**Engineering Support Services and Recommendations for Roadside Safety Issues or Problems  
for Member States**

Pooled Fund Program TPF-5(501)

**Engineering Opinion No. 202502**

**W-BEAM GUARDRAIL MOUNTED ON  
CONTINUOUS UNDERGROUND CONCRETE SLAB**

Figure 2. Post and Baseplate Details of the TTI Guardrail System (2).

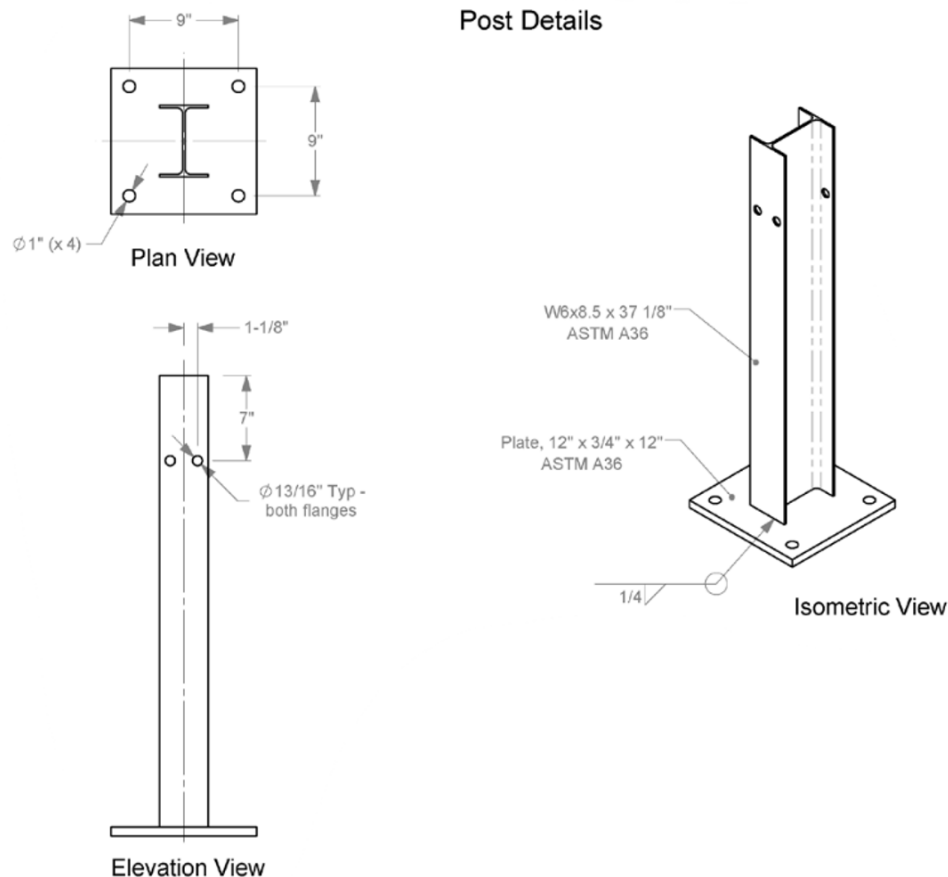
- The alternate anchor design should retain the post baseplate dimensions and material strength used in the TTI design (Figure 2).
- Guardrail posts should be buried 6 inches deep or more in the compacted road base like the TTI design. Additional evaluation through testing or analysis may be needed for depths less than 6 inches.
